ENGINEERING CHANGE ORDER			ECO No. <u>COS-086</u>	
Center for Astrophysics & Space Astronomy University of Colorado, Boulder			Date <u>23 May 2003</u>	
			Sheet <u>1</u> of <u>12</u>	
Drawing/Document Title	Drwg/Doc No.	Revision Letter		Special Distribution
		Current	New	
OP-01	COS-01-0001	22	23	
				Stop Production Now
				<input type="checkbox"/> Yes
				<input type="checkbox"/> No

Reason for Change: Updates to COS operations in OP-01.	Disposition/Effectivity				
	To Comply With ECO				
	Use As Is				
	Rework To ECO				
	Scrap And Rebuild				
	Record change Only				
	Other (See Above)				
Prepared By: <u>Jon Morse</u>	Date <u>23 May 2003</u>	CCB Required		<input type="checkbox"/> Approved	
Approved By: _____	Date _____	<input type="checkbox"/> Yes <input type="checkbox"/> No		<input type="checkbox"/> NotApproved	
Approved By: _____	Date _____	<input type="checkbox"/> Class I <input type="checkbox"/> Class II		Immediate	
Approved By: _____	Date _____			Incorporation	
Approved By: _____	Date _____			<input type="checkbox"/> Yes <input type="checkbox"/> No	
Approved By: _____	Date _____	Completion			
Project Mgr: _____	Date _____	Date

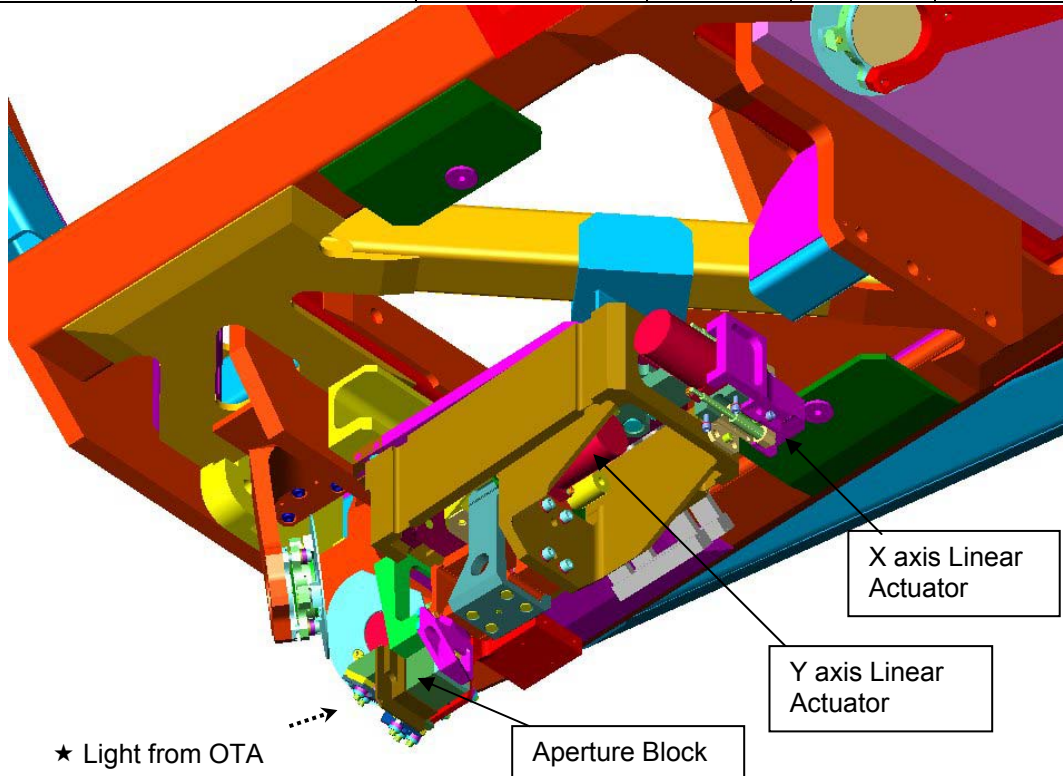
4. Page 32 (Rev. 22), Sec. 2.1.2.1: Replace Figure 2.1-2 with the following drawing:

The aperture mechanism is shown in Figure 2.1-2, and the placement of the science and calibration apertures on the aperture block is portrayed in Figure 1.3-8. Properties of the aperture mechanism, and parameters supplied to the FSW to operate it, are listed in the macro sheets LAPERINI, LAPERREL, and LAPER and Section 6.1 (Mechanism Limits and Settings) of DM-05. Additional information may be found in Appendix A of the Flight Software User's Manual (Control Section Hardware/Software Interface).

Figure 2.2-3: Color-coded schematic of safe and unsafe usage configurations for the Pt-Ne wavelength calibration lamps with the various COS gratings and mirrors.

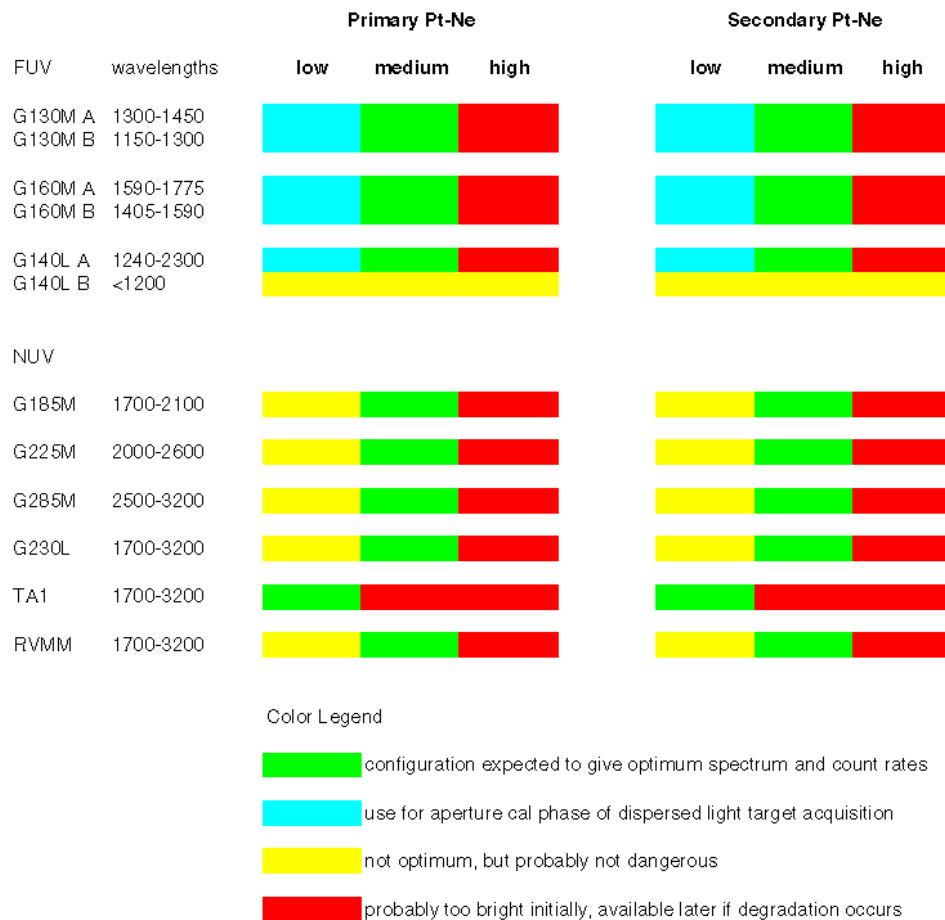
19. Page 52 (Rev. 22), Sec. 2.2.2: Insert the following text and figure after the paragraph that ends “... over the life of the mission.”

Figure 2.2-3 shows a schematic of Pt-Ne lamp current settings versus optic configuration to be used as a guide in assessing safe usage of the wavelength calibration lamps, particularly applicable to the beginning of the mission life.

Figure 2.2-4: Color-coded schematic of safe and unsafe usage configurations for the deuterium flat-field calibration lamps with the various COS gratings and mirrors.

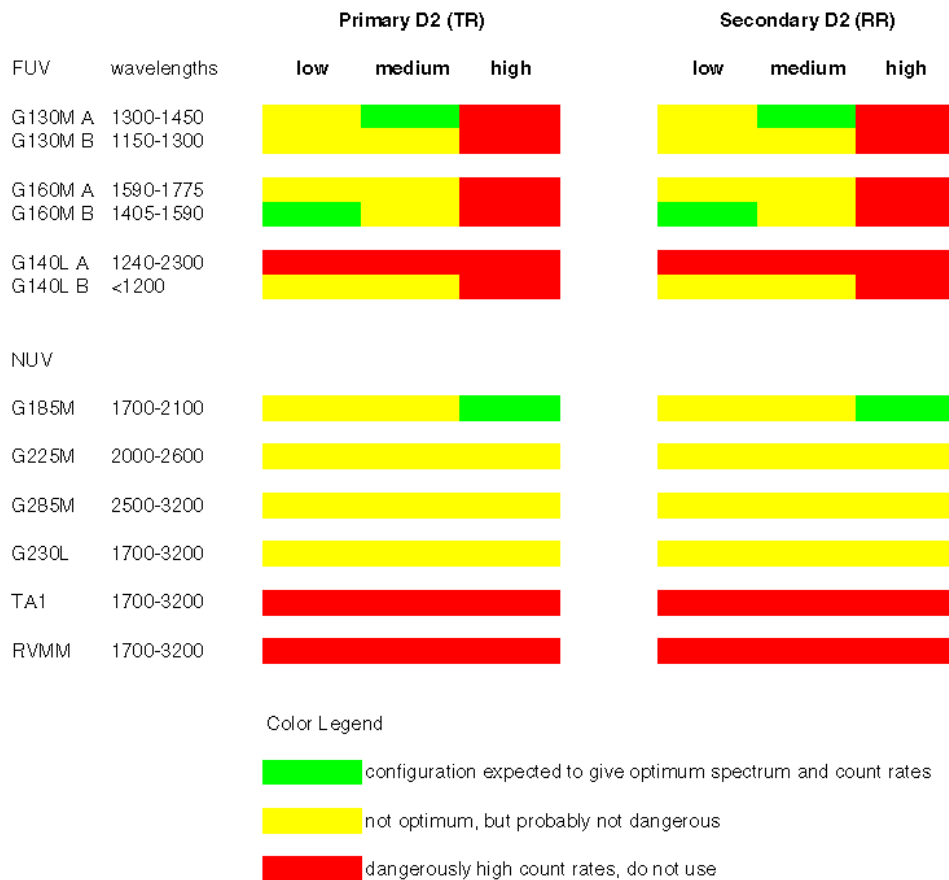
22. Page 54/55 (Rev. 22), Sec. 2.2.3: Delete Table 2.2-4, and rename Table 2.2-5 to 2.2-4. In place of Table 2.2-4, insert the following figure and caption:

There are two deuterium flat-field lamps, each with three current settings. For both lamps the levels are 3, 7, and 17 milli-amps. In general, either the low or medium setting should be used with the FUV gratings G130M and G160M. G130M will be used to flat-field segment A of the FUV detector using the medium setting. G160M will be used to flat-field segment B of the FUV detector using the low setting. For the NUV channel, the total throughput is low and G185M will be used with the high setting to flat-field the three science stripes on the NUV detector. Figure 2.2-4 shows a schematic of deuterium lamp current settings versus optic configuration to be used as a guide in assessing safe usage of the wavelength calibration lamps, particularly applicable to the beginning of the mission life.
